Review of seismic-hazard issues associated with the Auburn Dam project,
Sierra Nevada foothills, California

USGS Auburn Project Review Team¹

Open File Report 96-0011

Figure 1. Map showing Auburn Dam site, traces of Foothills fault system (Jennings, 1994), and locations of other western Sierra dams (circles).

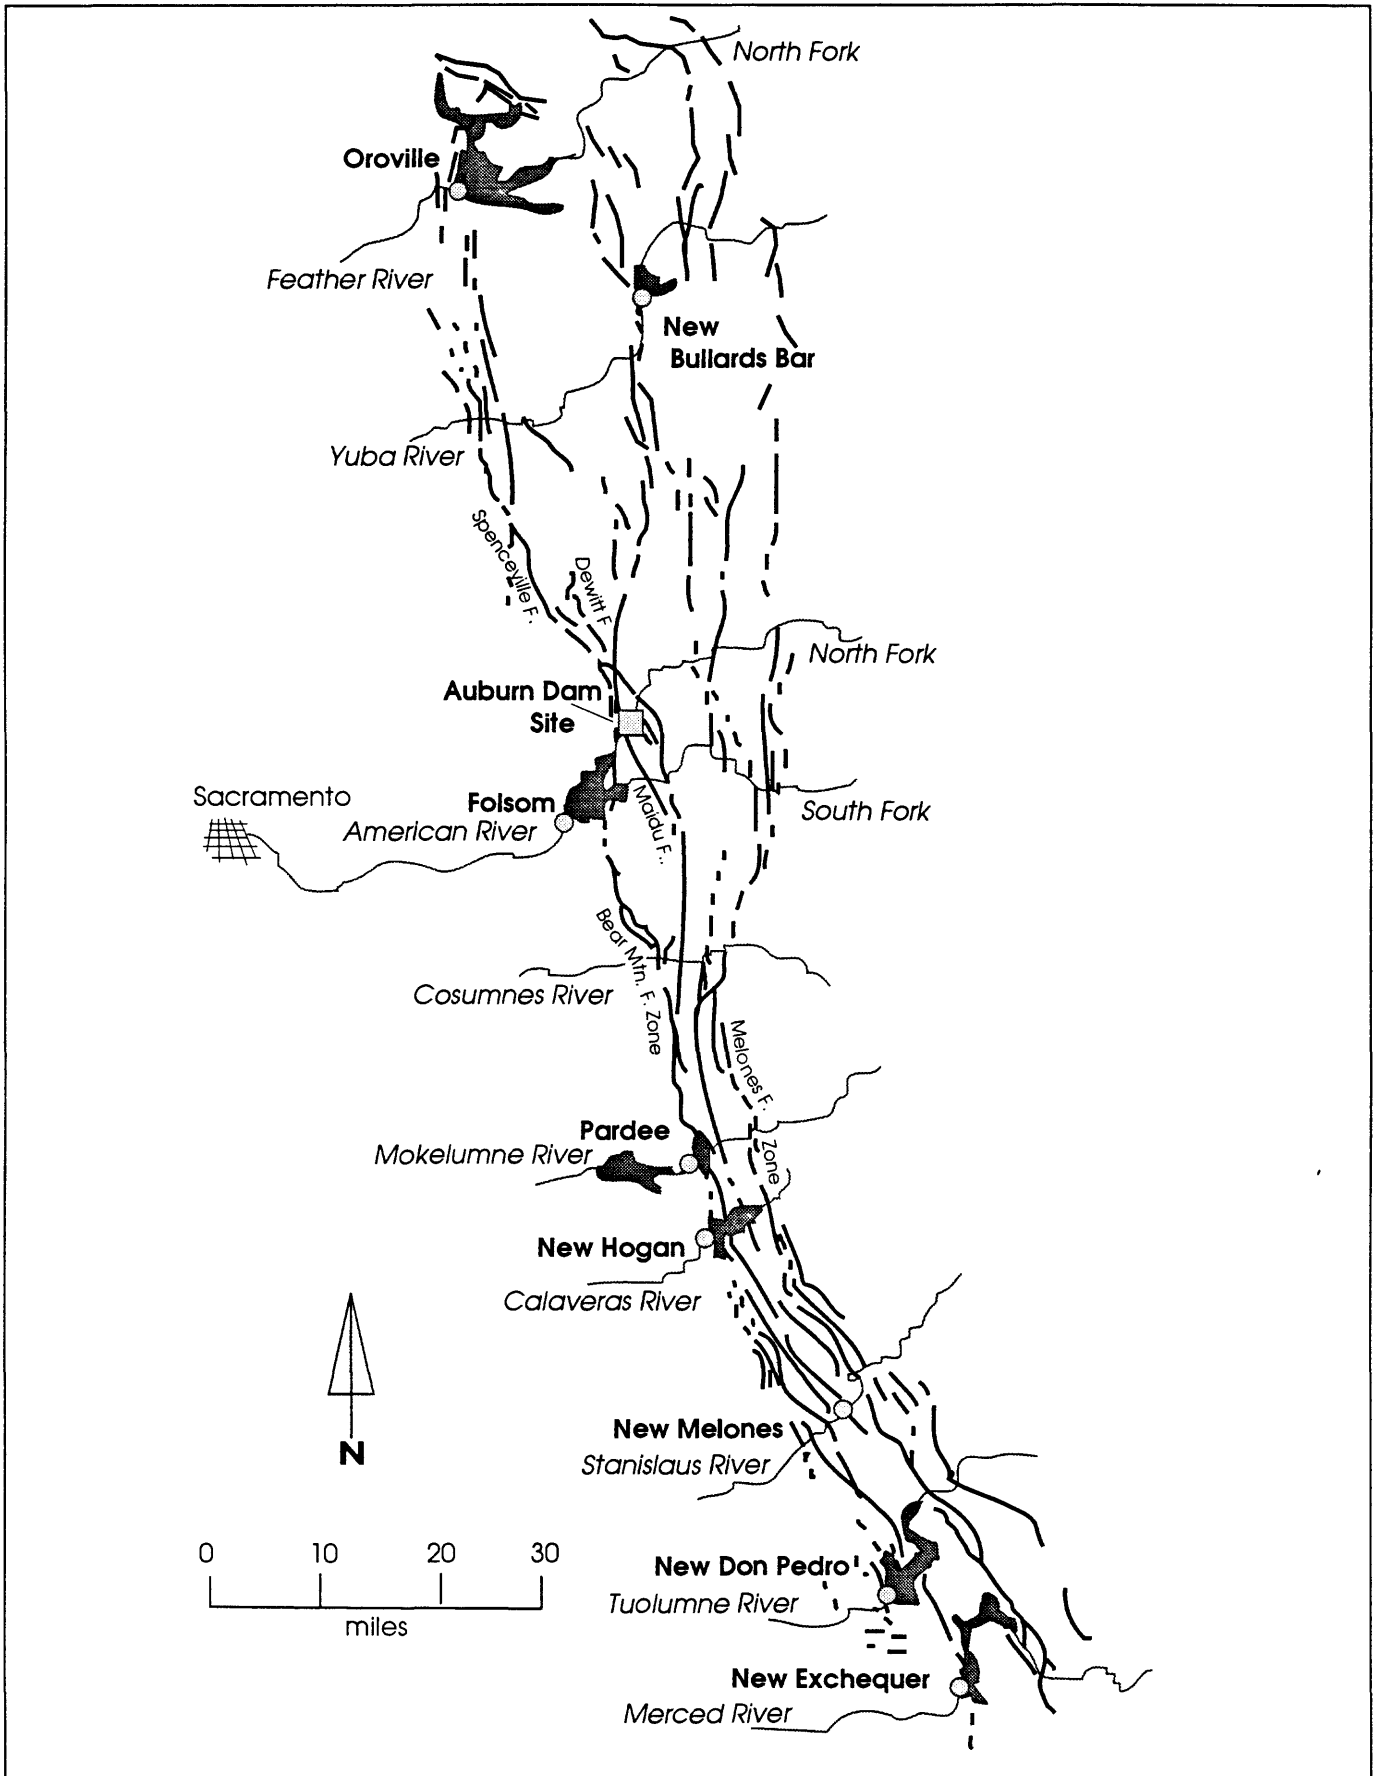
How reasonable is the 9-inch value in light of geological work conducted in the Sierran foothills since 1979 and our present understanding of surface faulting? Recent studies of potentially active faults have been completed by PG&E (1994) for the Rock Creek Dam just north of Auburn and by the Corps (1995) for the New Hogan reservoir on the Calaveras River (Figure 1). Trenching of the Dewitt fault, Deadman fault, and Highway 49 fault near

Fig. 2. Seismicity before (left panel) and after (right panel) the impoundment of the Nurek reservoir. The outline of the full reservoir is shaded in both panels. Note that seismicity is concentrated near the reservoir following impoundment. From *Simpson and Negmatullaev [1981]*.

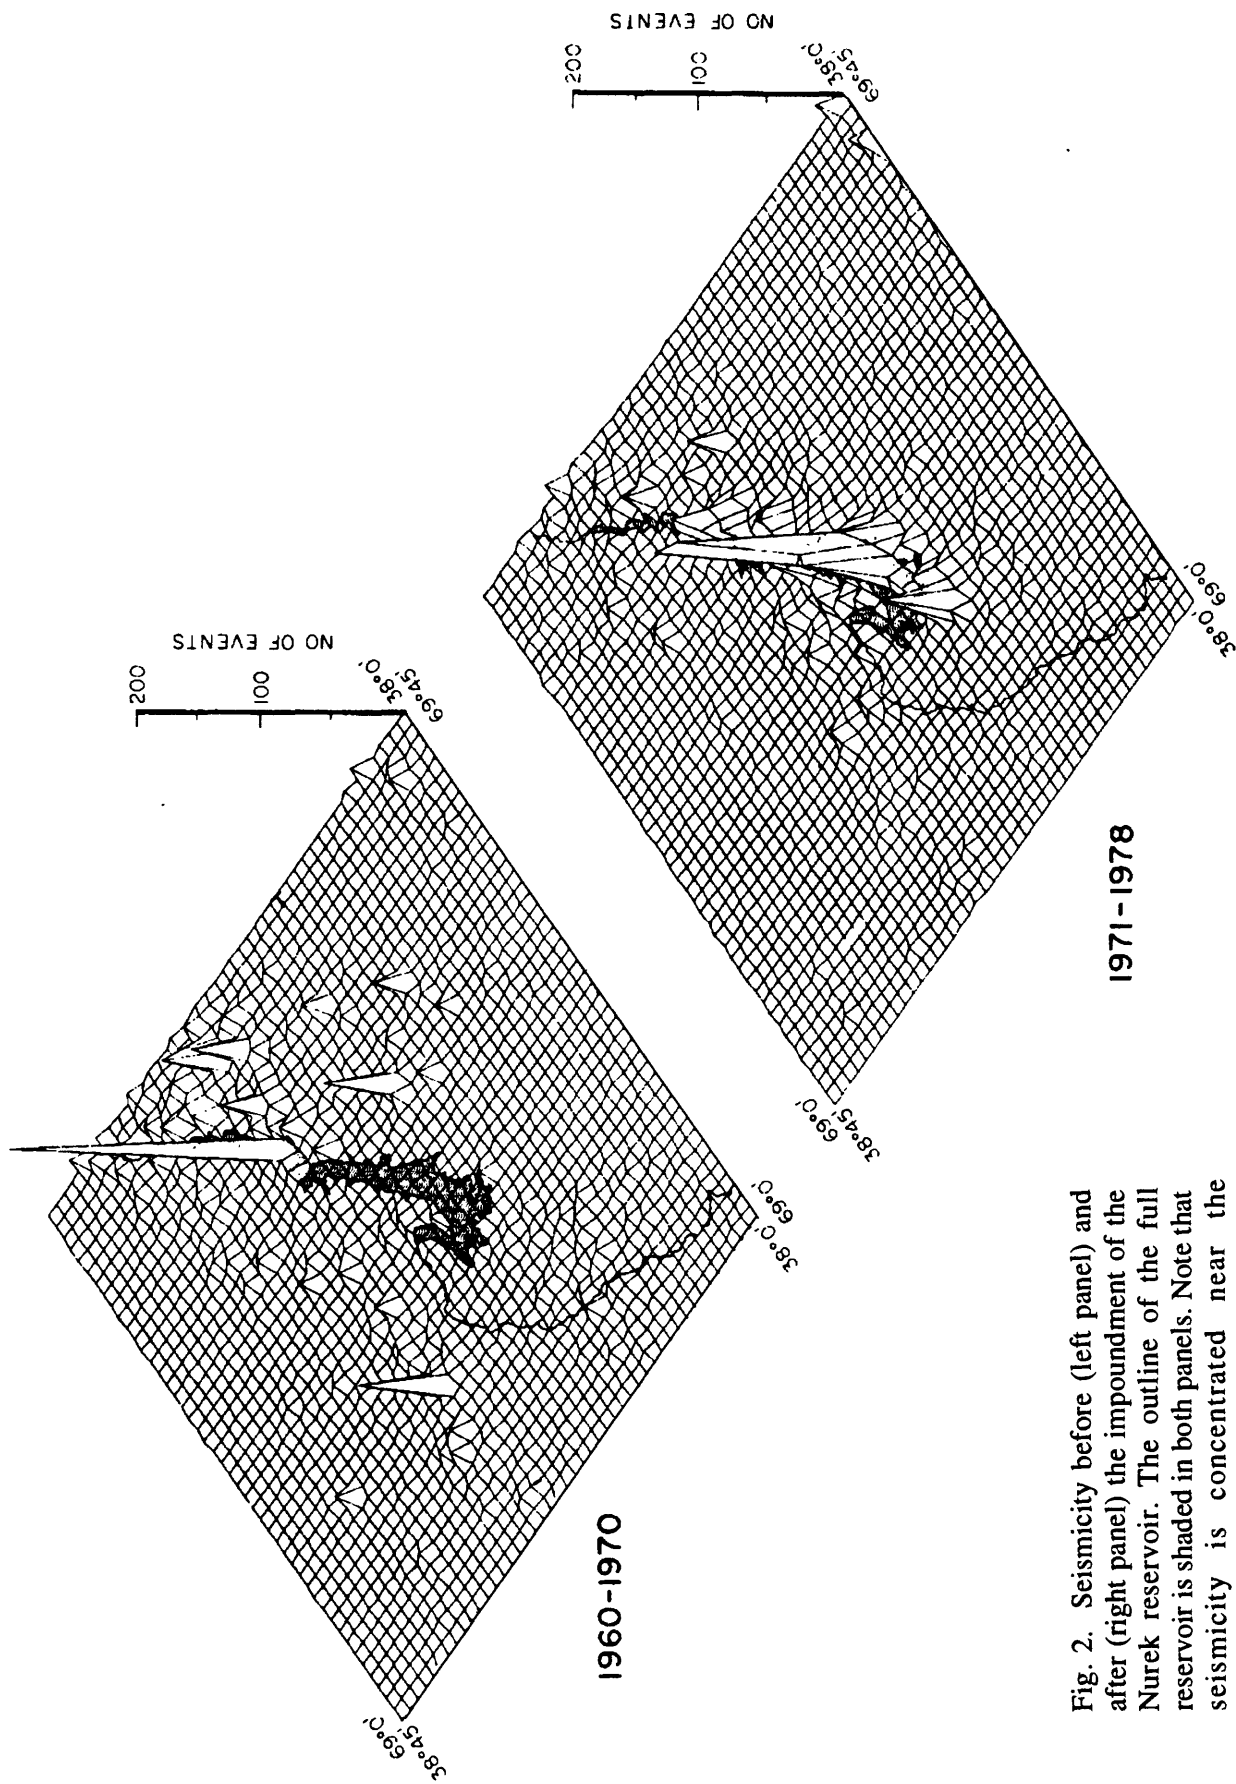
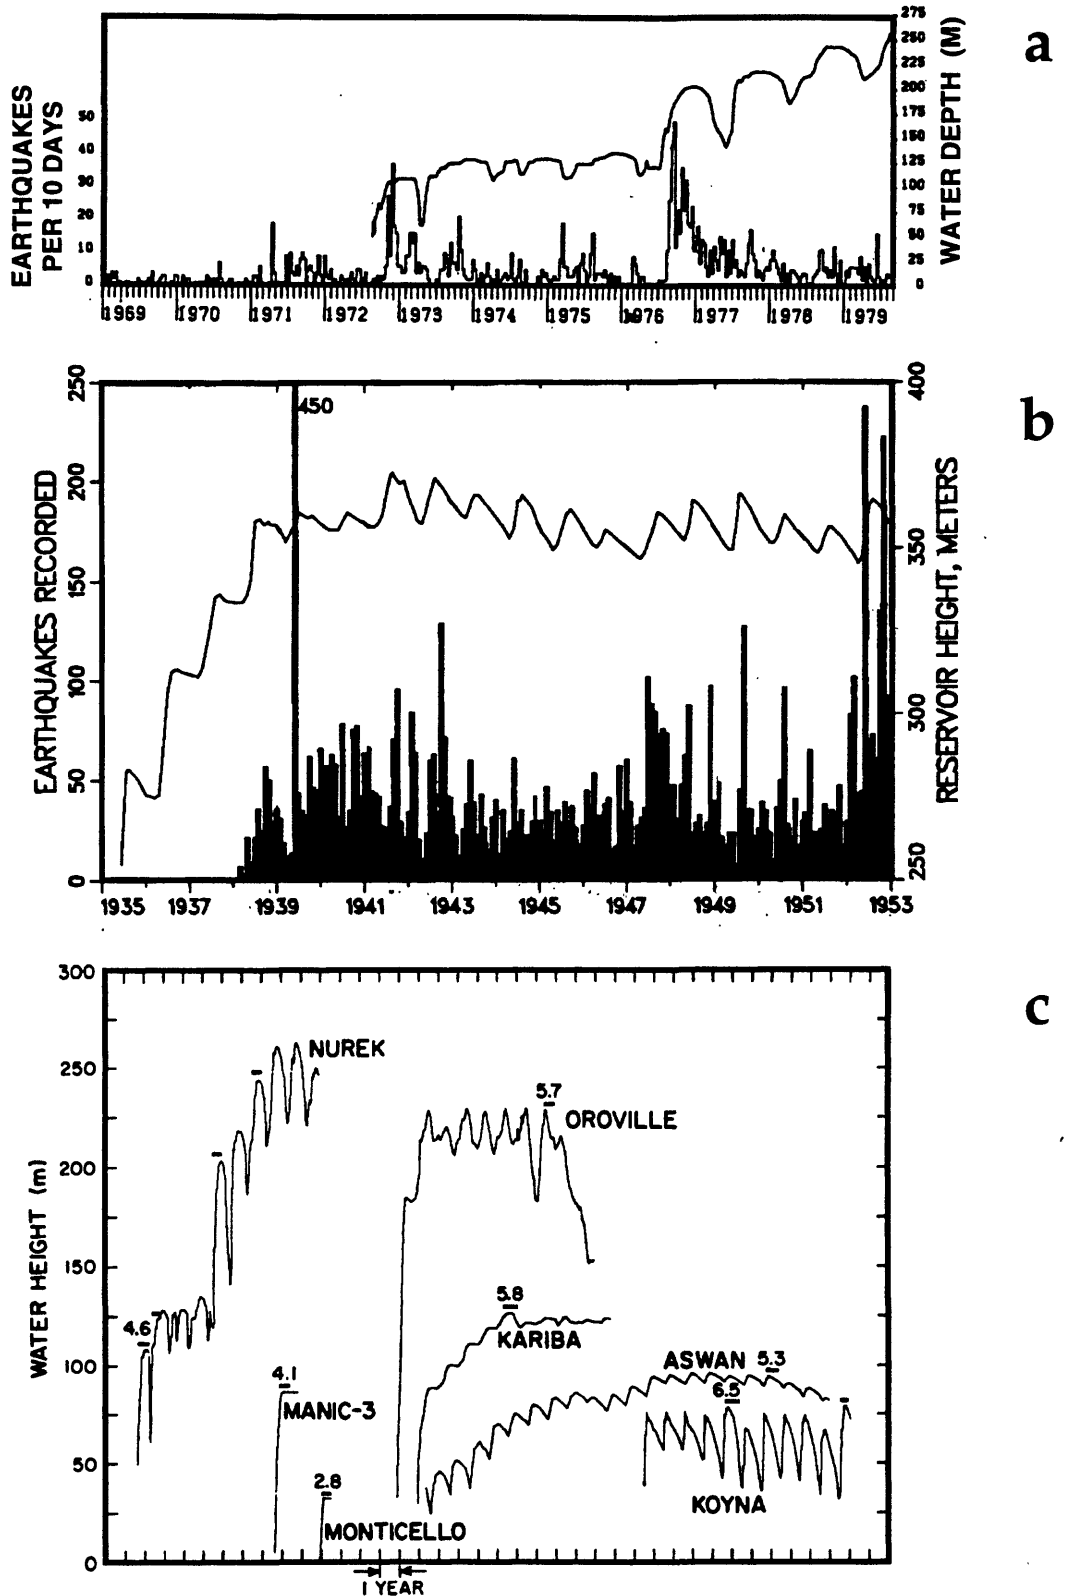
- 4) The probability of the occurrence of earthquakes at and in the region around a reservoir may be increased by impoundment. In a few of the best controlled studies where a reliable record of seismicity before and after reservoir impoundment exists (Segall, Grasso, and Mossop, 1994; Simpson and Negmatullaev, 1981), an increased rate of activity is seen within 10-15 km of impounded reservoirs and gas fields (Figure 2 and Figure 3).
